Access Compliance Report Public Rights-of-Way (Curb Ramps)

Intersection ID: 9783 Main Street: WARP ST **Cross Street: DONATELLO AV** Location: NW **Overall Compliance: No Severity Score:** ADA ID: 98BEA7DB510C Ramp Type: BlendTrans2 Initial Pass/Fail: Fail 12.5

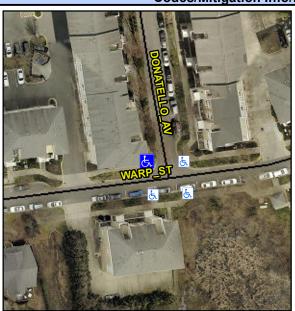
WARP ST Street 1 Name Stop Condition-Street 1 None **DONATELLO AV** Street 2 Name Stop Condition-Street 2 StopSign Possible Solutions: Compliance Description N/A Remove & Replace Curb Ramp With Two New Directional Ramps or Equivalent. Surveyor Notes: SURFACE PAVERS, UNEVEN PROW/ADA: Not Found, R304.5.3
